## Parramatta Bike Plan Refresh Feedback

These comments have been prepared on behalf of CAMWEST, a Bicycle NSW affiliated Bicycle User Group with a focus on advocating for and encouraging cycling in Western Sydney.

*Painted guidance for crossing the tracks at Newington Armory.  
Photo by Charlene Bordley.*

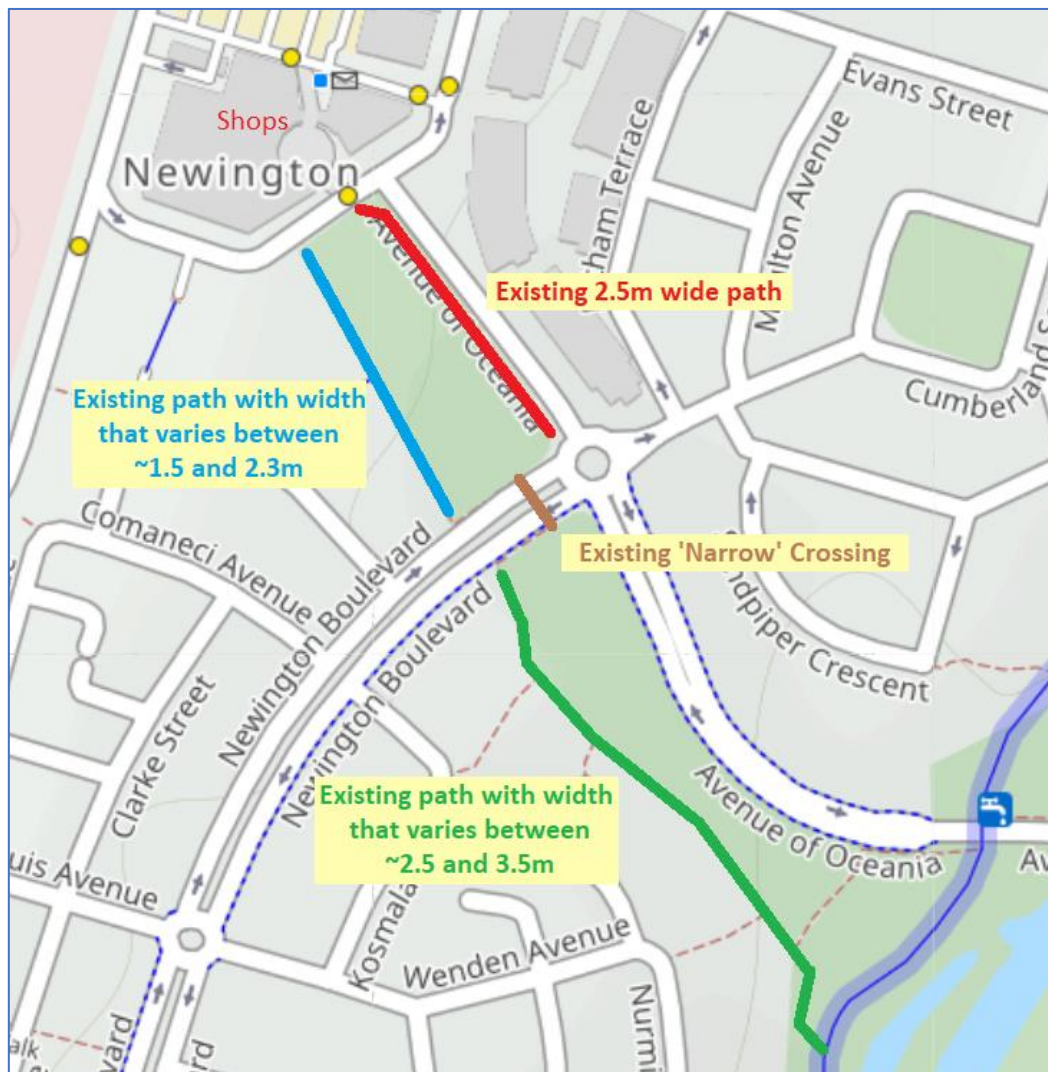
- Options need to be explored so riders can safely cross tram tracks without dismounting. Options may include track insert devices or painted on-road arrows encouraging riders to cross perpendicular to the tracks. Although we believe it could be improved upon, there is a recent example of this approach at Newington Armory. Riders in other cities (e.g., Melbourne) seem to be able to negotiate track crossings successfully.

*Top of rail embankment, looking NE across Edwin Flack Ave to the narrow embankment on the other side and beyond to the Warm-Up Arena.*

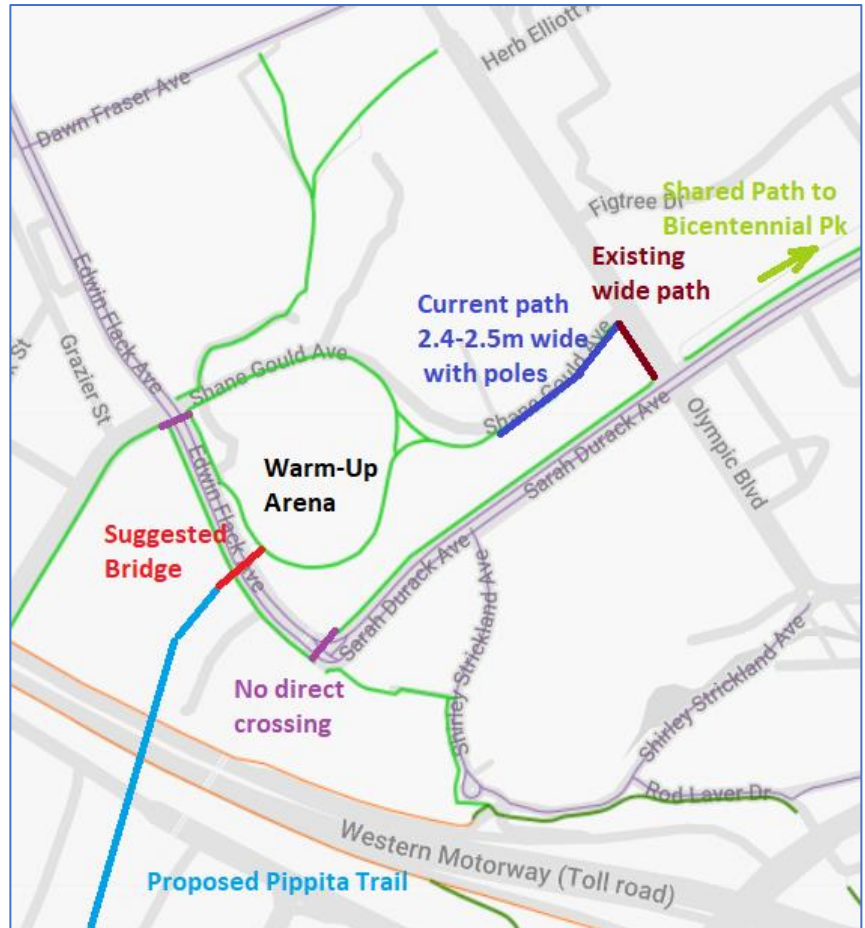
2. We note that the proposed Pippita trail is shown as ending at Edwin Flack Ave. We believe that with the existing height of the embankment, a bridge across Edwin Flack Ave virtually at level would be preferred than trying to build a ramp down to the roadway with riders needing to cross Edwin Flack Ave, and then having to partially ascend the hill on the other side. The following comments are taken from feedback that CAMWEST submitted to Cumberland Council on the Pippita Trail <sup>[3]</sup>:

The rail embankment finishes on the south-western side of Edwin Flack Ave. There is a fair height differential between the top of the embankment and the path along the SW side of Edwin Flack Ave, meaning a steep ascent/descent would be required if terminating the Trail here.

The path along the SW side of Edwin Flack Ave is currently only 1.8m wide in places, and there are no ready crossings to get to:

- The path alongside Shane Gould Ave (3 way crossing at signalised intersection required),
- Sarah Durack Ave (4-way crossing required), and
- The wider path running alongside the NE side of Edwin Flack Ave.

If possible, a bridge across Edwin Flack Ave to join up with the existing path around the Warm-Up Arena would be the ideal – but the existing narrow embankment along the NE side of Edwin Flack Ave may present some challenges.

If planning to use this route around the Warm-Up Arena, some of the existing path alongside Shane Gould Ave would probably need to be widened as the current path varies between 2.4 and 2.5m wide with lamp posts in the middle.

Marked-up Google Satellite view image of the Beaconsfield St crossing of Silverwater Rd.

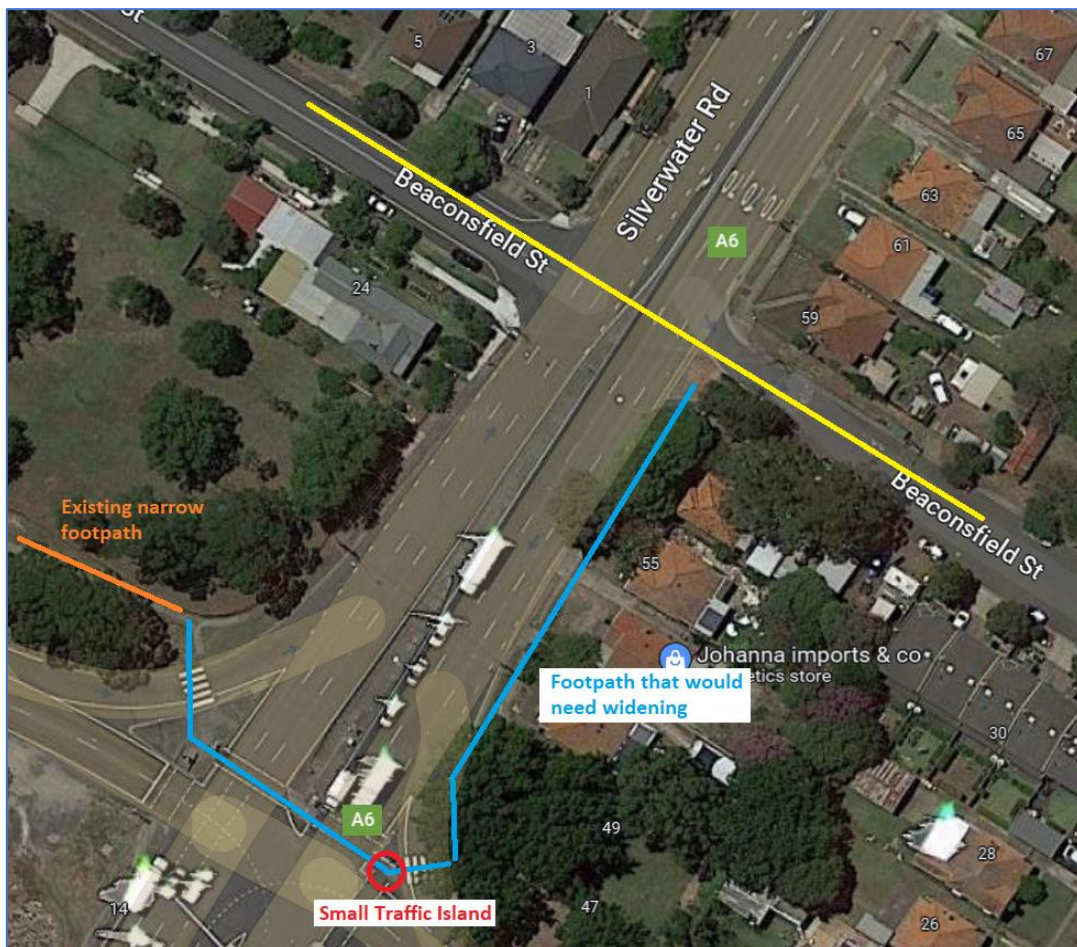
3. The plan shows a proposed crossing of Silverwater Rd at Beaconsfield St just north of the M4 entry and exit ramps (Yellow line in below image). We don't see this as realistic unless a bridge is built to span Silverwater Rd.

- a. To cross Silverwater Rd at this point involves crossing 3 lanes of traffic in each direction with a posted speed limit of 70kmph. A refuge island could probably be created in the middle, but even then, it's incredibly dicey for riders.

- b. A signalised crossing here is unlikely as the M4 entry and exit ramps signalised crossing is just over 80m to the south.
  - c. Paths could be widened on one or both side of Silverwater Rd between Beaconsfield St and the signalised intersection. However, the traffic island on the eastern side is small – pretty much mirroring the problematic island on the south side of the M4 (in Cumberland LGA) that is part of the existing M4 cycle route between Adderley Streets East and West.

- d. Although CAMWEST wouldn't object to two bridges being built across Silverwater Rd, we feel that the crossing on the southern side between Adderley Streets East & West would get more use than one crossing at Beaconsfield St.

Marked-up rendering from the cycling layer of Open Street Map <sup>[2]</sup>

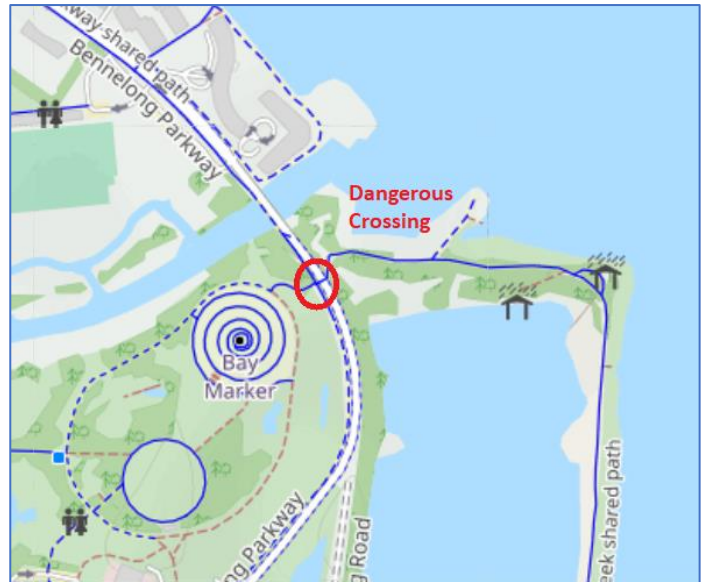
4. Although not new infrastructure, the road crossing of Bennelong Parkway with the Parkway Circuit/Powells Ck Shared Path (East of Haslams Ck) is quite dangerous. We're not sure whether that comes under Council's or SOPA's jurisdiction – but believe making it safer should be a priority. While the proposed bridge across Haslams Ck on the north side of Bennelong Pkwy will be a welcome addition, we believe a safe crossing of Bennelong Pkwy will still be required. The crossing forms a link in a popular route between Wentworth Common & the Bay Marker and the main cycling route into Bicentennial Park.
